2528 MAPLE STREET (COMPLETE APPLICATION)  
DE410957 - ZONE C-3A

**EXECUTIVE SUMMARY**

- **Proposal:** To develop this site with a seven-storey mixed-use Retail/Residential building, containing 74 dwelling units over two levels of underground parking.
- **Purpose of this report:** The Board is asked to consider a relaxation of the minimum rear yard requirements and a discretionary height increase, which have only just come to light.

**DEVELOPMENT PERMIT STAFF COMMITTEE RECOMMENDATION: APPROVE**

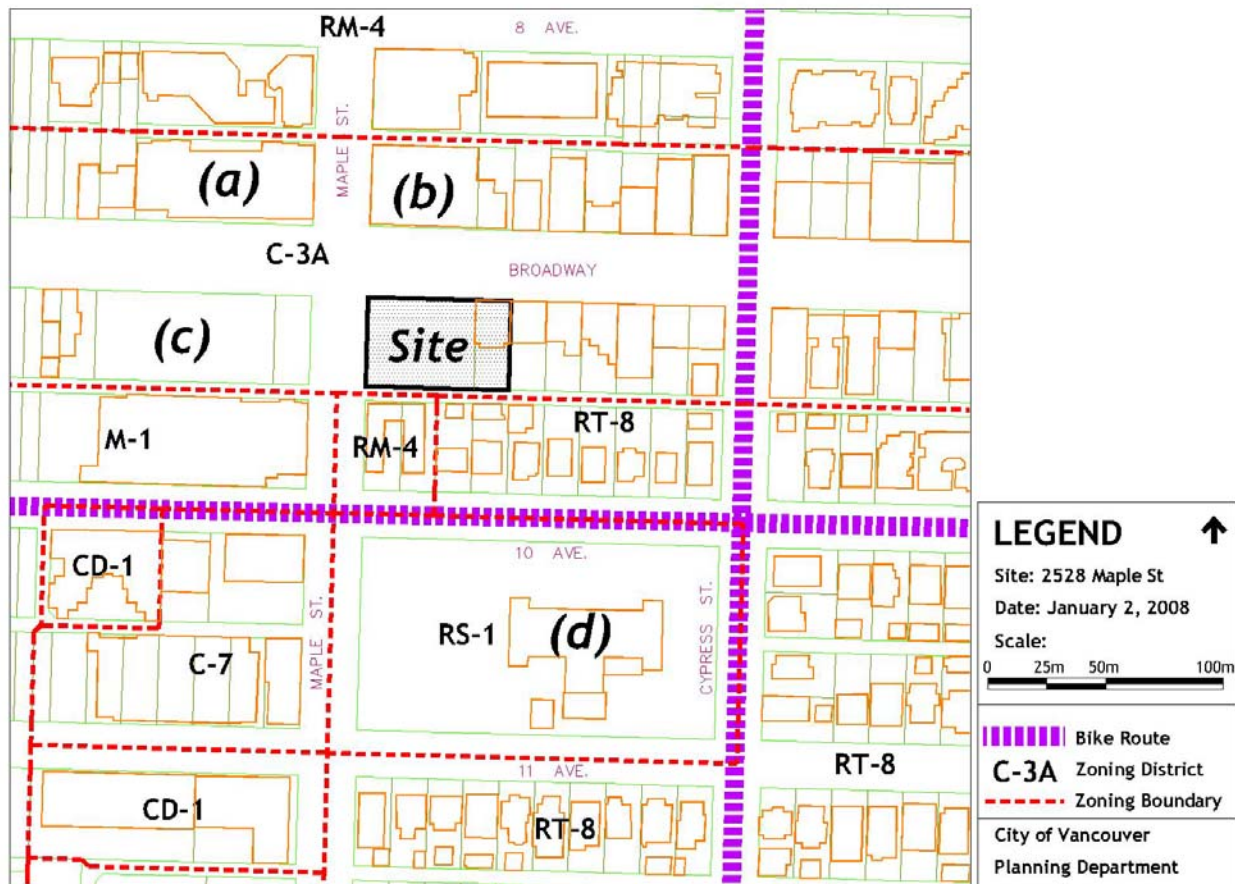
• **Site:** The site is located at the southeast corner of Broadway and Maple Street. The site slopes down approximately 4 ft. from the lane to Broadway and approximately 3 ft. down from the Maple Street corner to the east property line.
